ADDENDUM NO. 3

Reference: HVAC and Electrical Systems Upgrade
Ft. Douglas Museum – Phase 2A – Utah National Guard
DFCM Project No. 08249470

PROJECT NAME: Ft. Douglas Museum Phase 2A
Mechanical & Electrical Systems
31 Potter Street
Ft. Douglas, UT 84113

MAIN LEVEL FLOOR PLAN

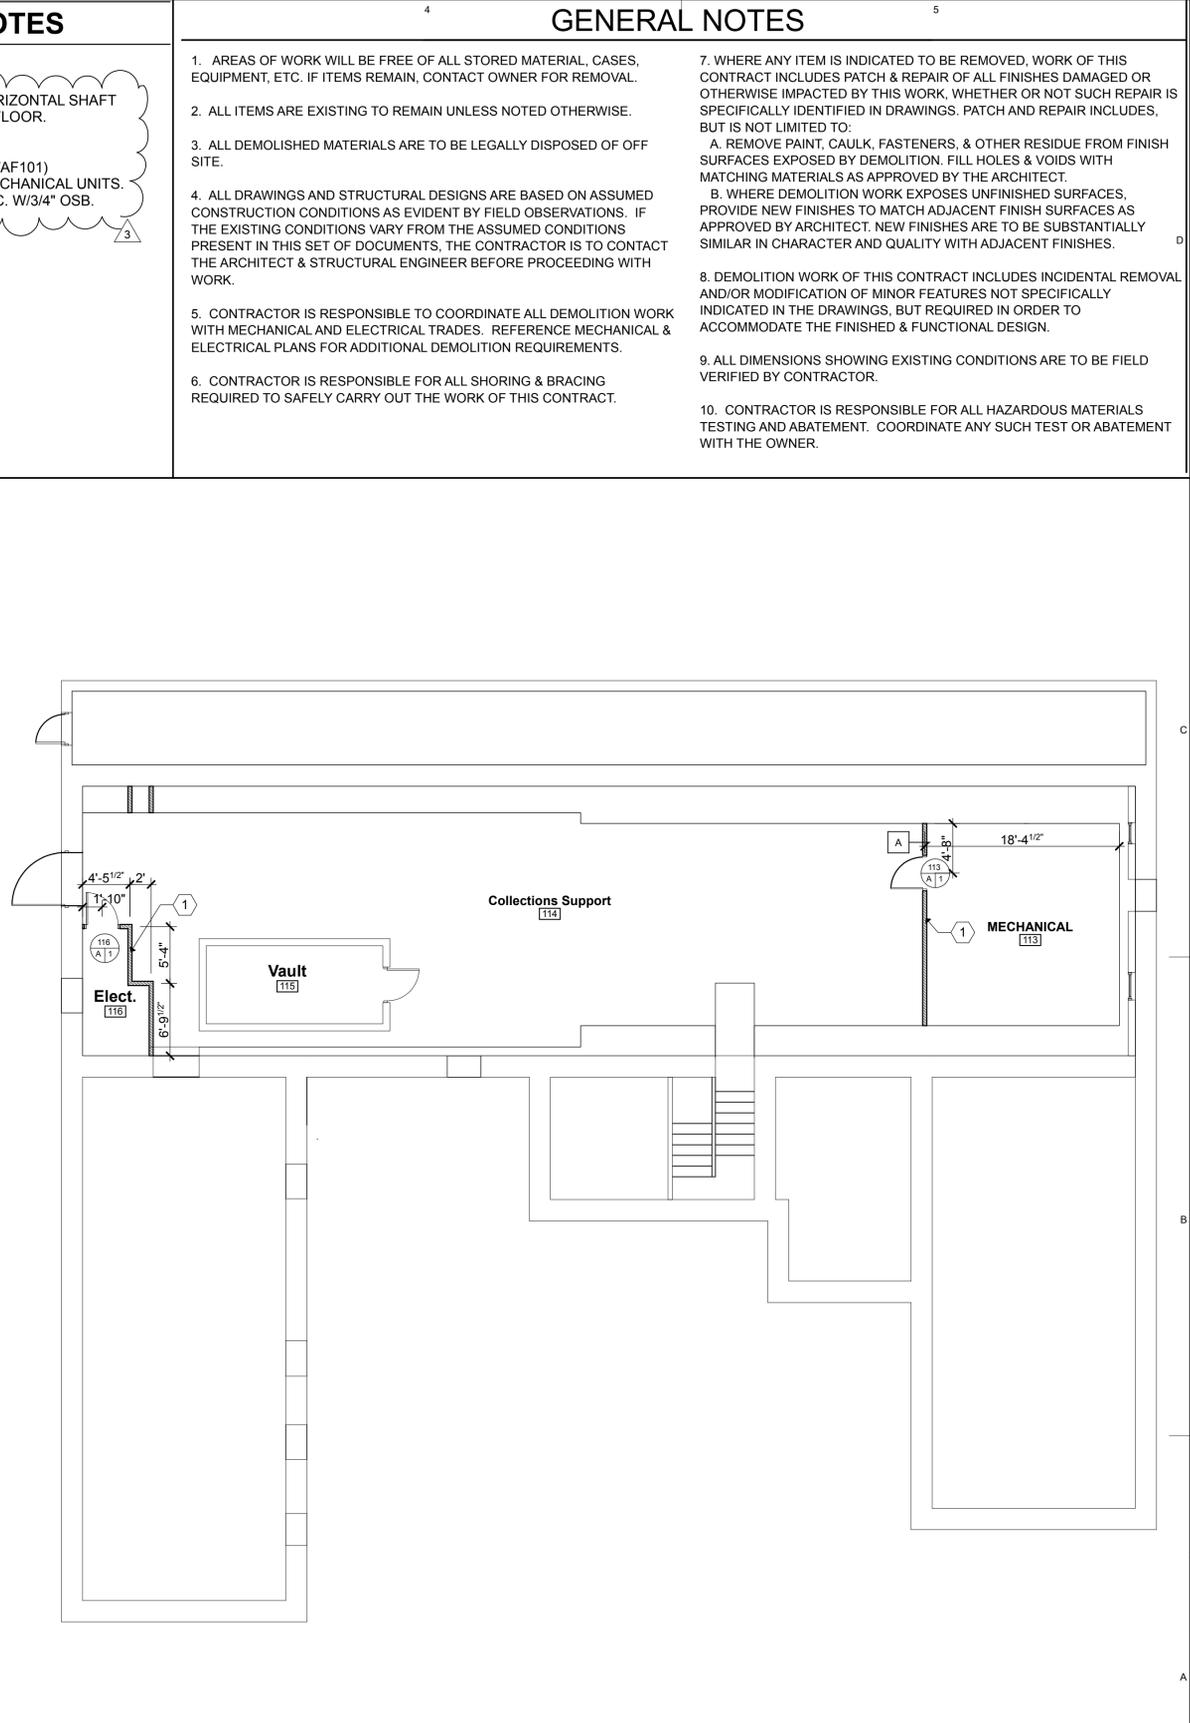
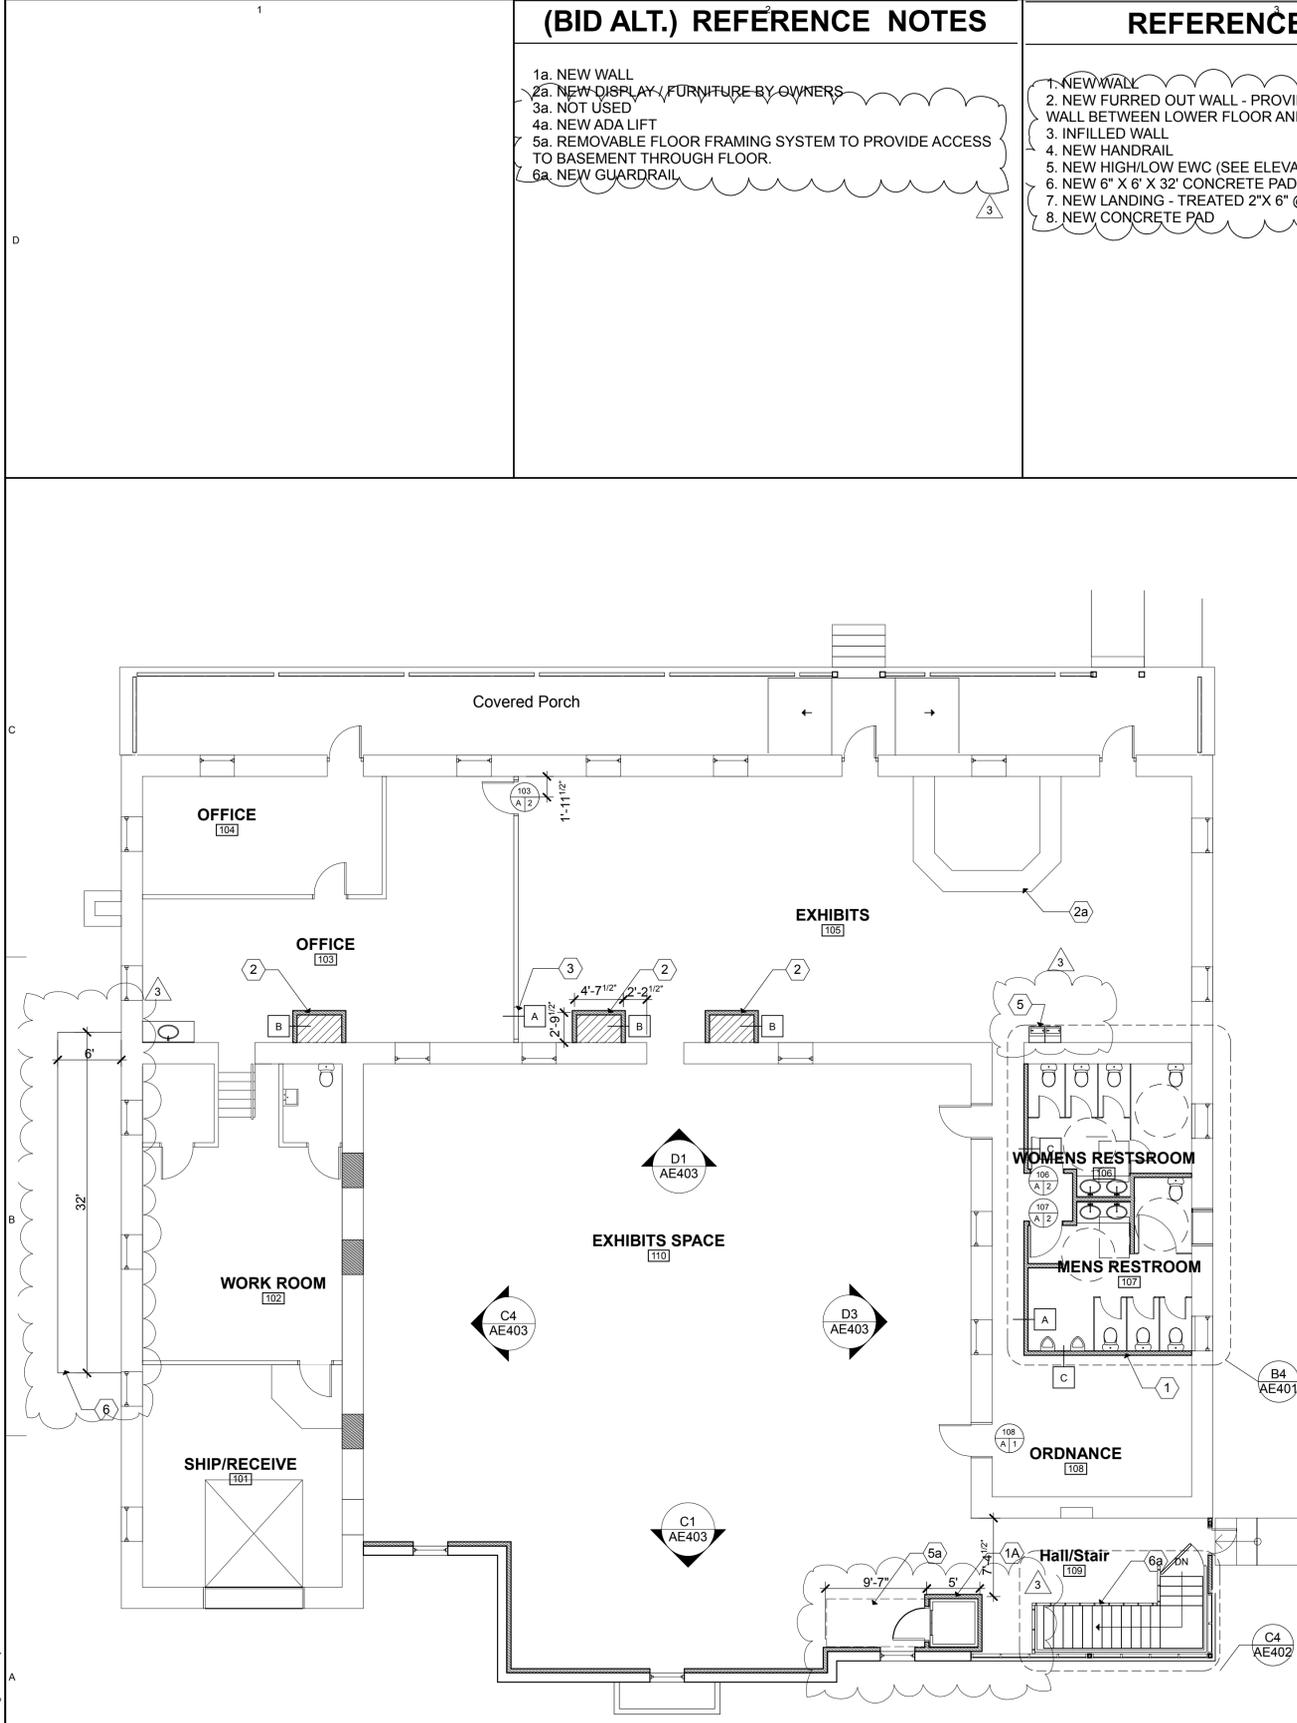
- VI-8 AE102 Main Level Floor Plan
 - a) Added new concrete pad.
 - b) Modified Bid Alternate reference notes 3a, 4a, 5a & 6a.
 - c) Added reference notes 6, 7 & 8.

- d) Revised reference note 2 to reflect new furred out wall and horizontal shaftwall at floor level in lieu of rated shaft. Note: the construction of this wall remains the same but it is not required to be a fire rated shaft.

- e) Relocated wall behind vertical platform lift & extended west end of guardrail to window.
- f) Modified the electric water cooler symbol in Exhibits 105 to reflect a 2 cooler unit.

MAIN LEVEL REFLECTED CEILING DEMOLITION PLAN

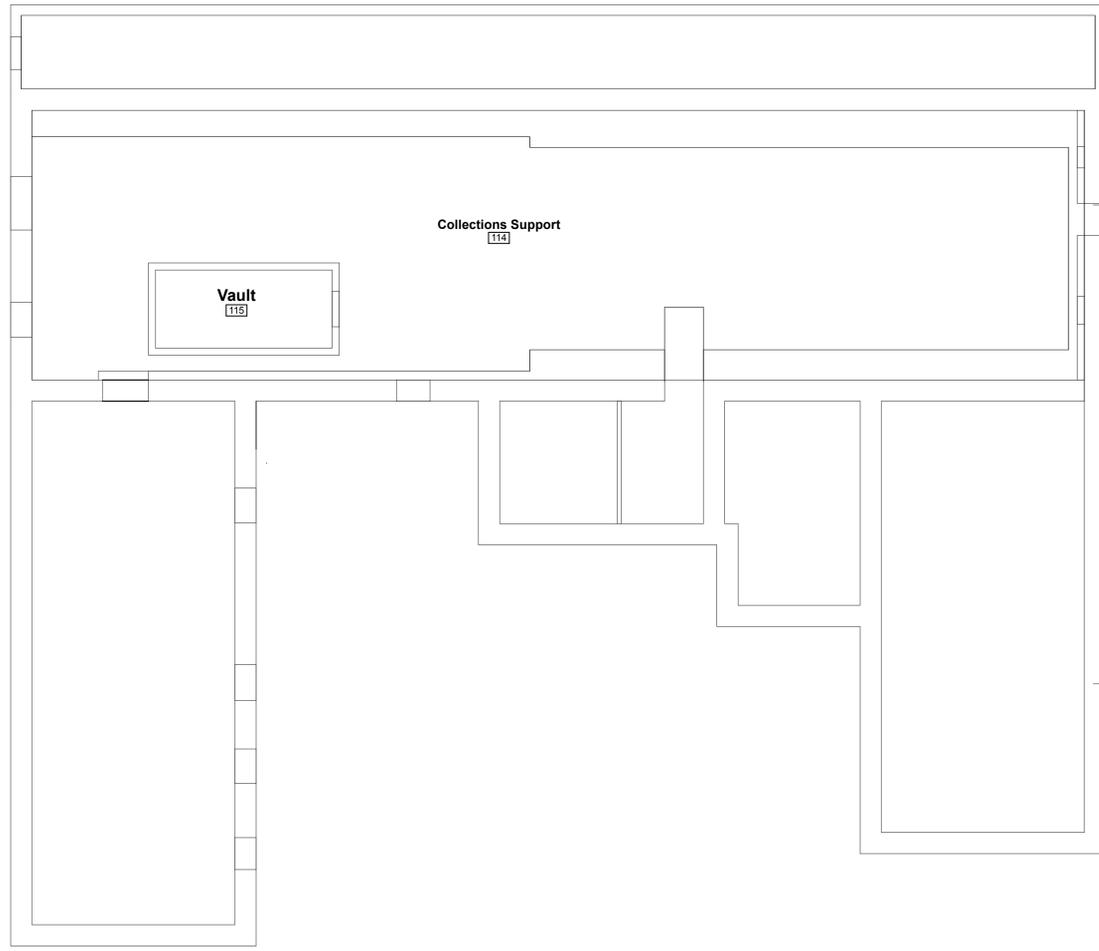
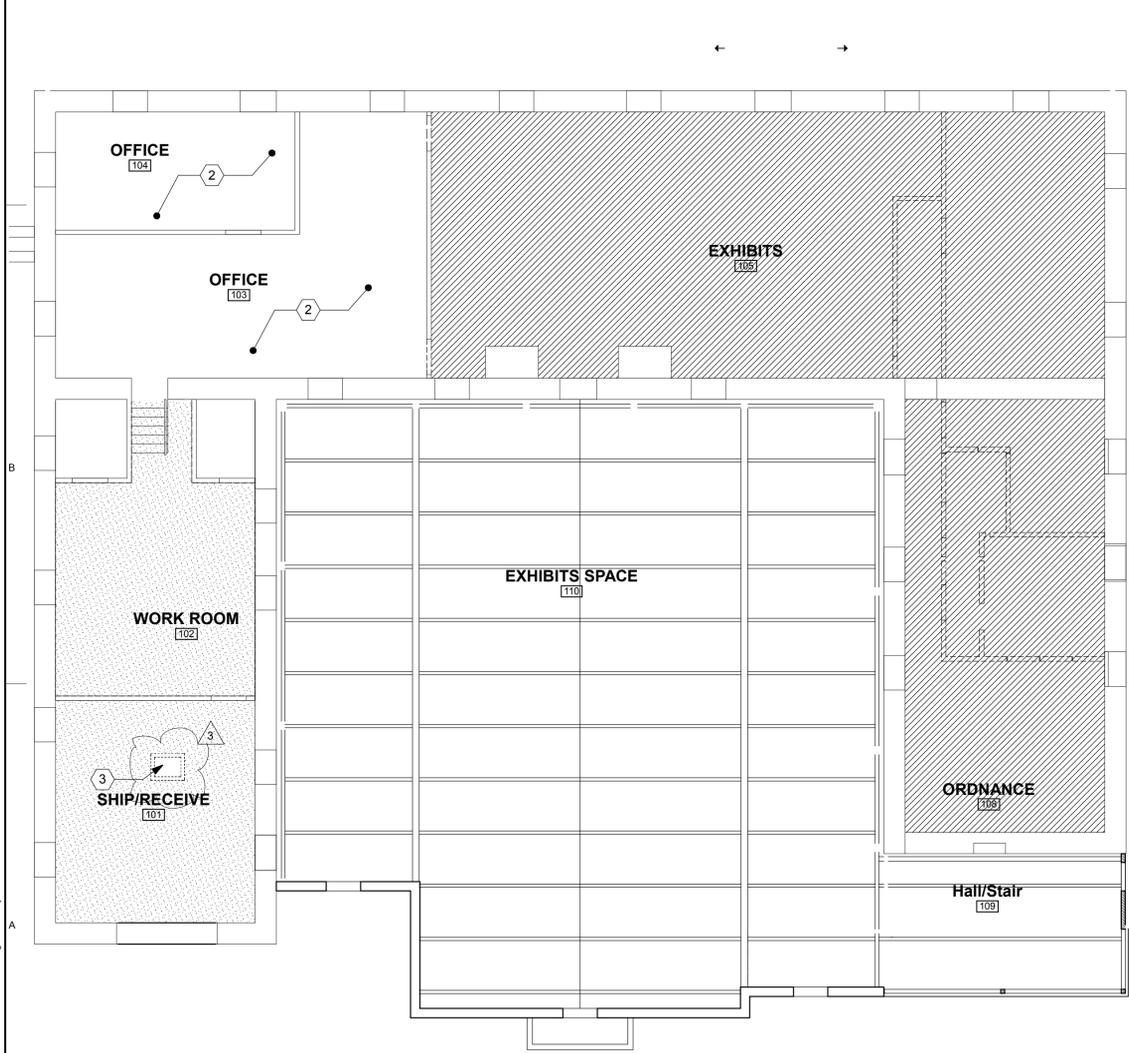
- VI-6 AD103 Main Level Reflected Ceiling Demolition Plan
 - a) Added the attic access demolition and reference note
- VI-7 AE101 Lower Level Floor Plan
 - a) Added door 004A.

LOWER LEVEL REFLECTED CEILING PLAN

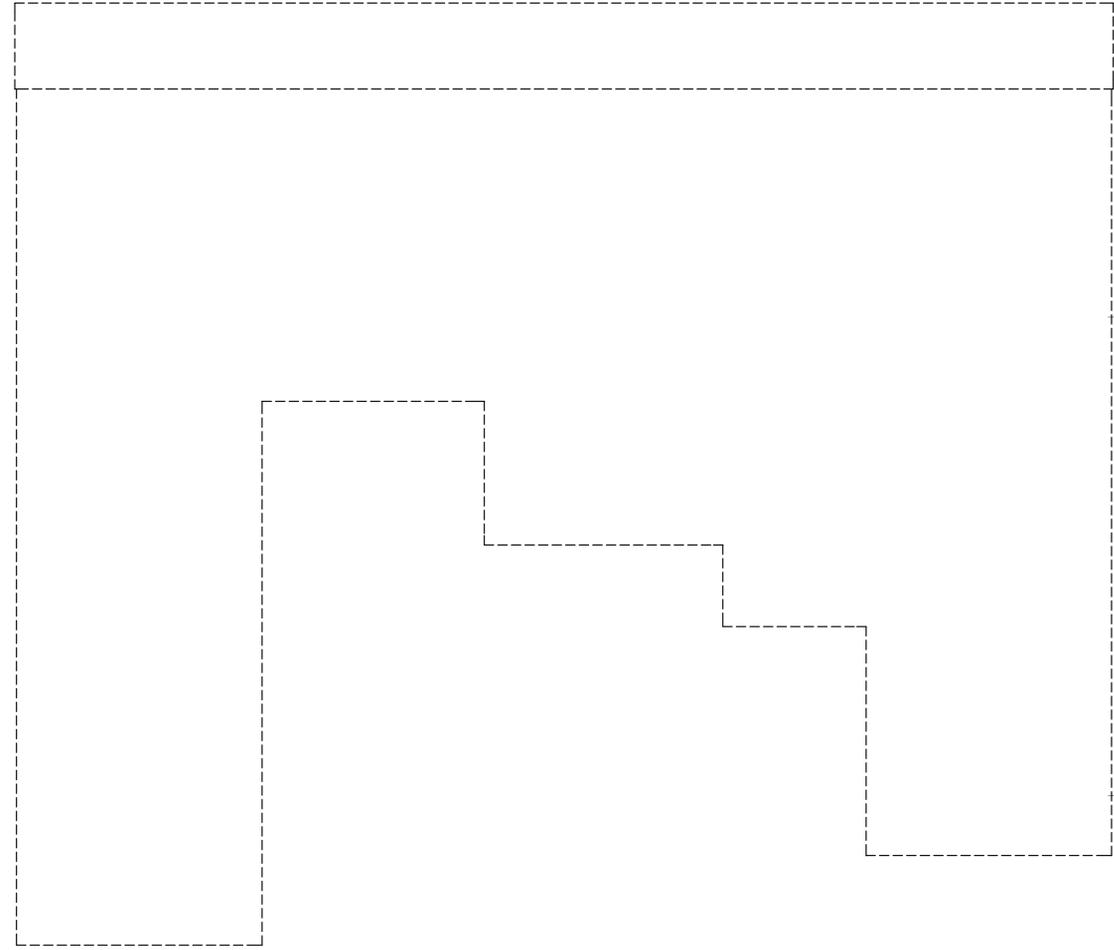
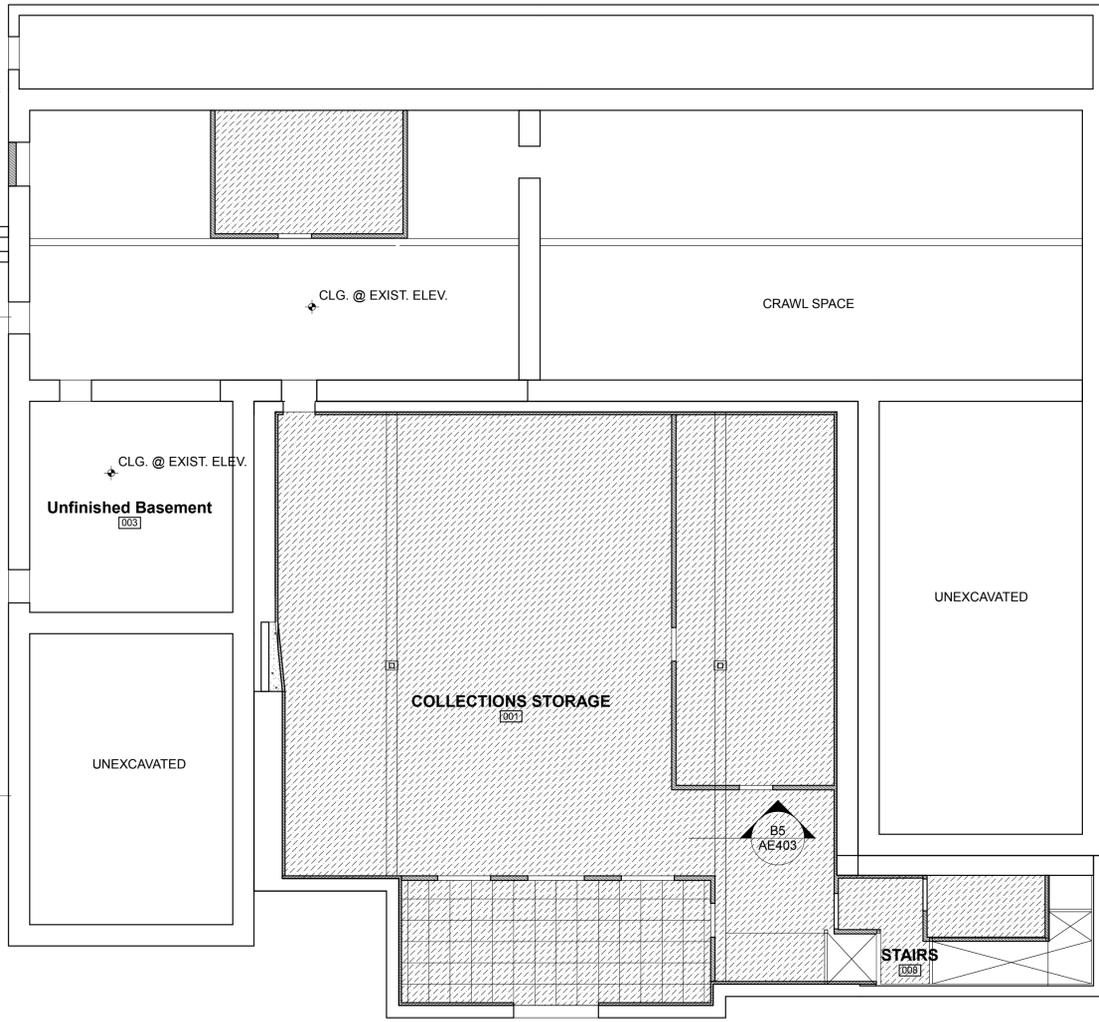
- VI-9 AE110 Lower Level Reflected Ceiling Plan
 - a) Added reference note #5.
- VI-10 AE111 Main Level Reflected Ceiling Plan
 - a) Added new attic access hatch & reference note #5.

C4 ENLARGE MAIN LEVEL STAIRS
1/2" = 1'-0"

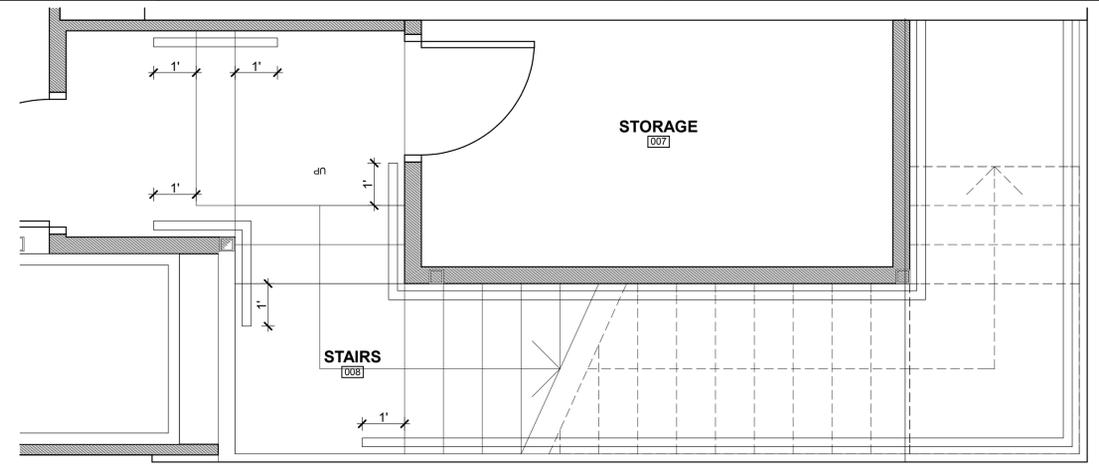
- VI-11 AE401 Enlarged Floor Plan & Details
 - a) Added dimensions to B4.
- VI-12 AE402 AE401 Enlarged Floor Plan & Details
 - a) Added break line to C4.
 - b) Modified details B2 & A2 to show 2" handrail. The lines in the guardrail and support posts indicate a round section, not the grain direction.

B1 ADA MOUNTING HEIGHTS
1/2" = 1'-0"

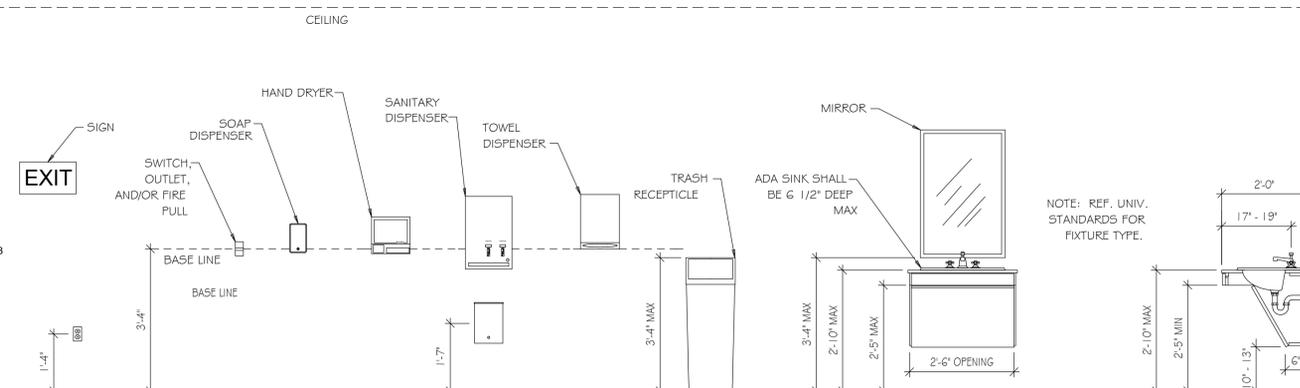
- VI-13 AE403 Interior Elevations & Details
 - a) Modified detail B1 to show vertical grab bars and dimensions.
- VI-14 AE601 Door & Windows Schedules & Details
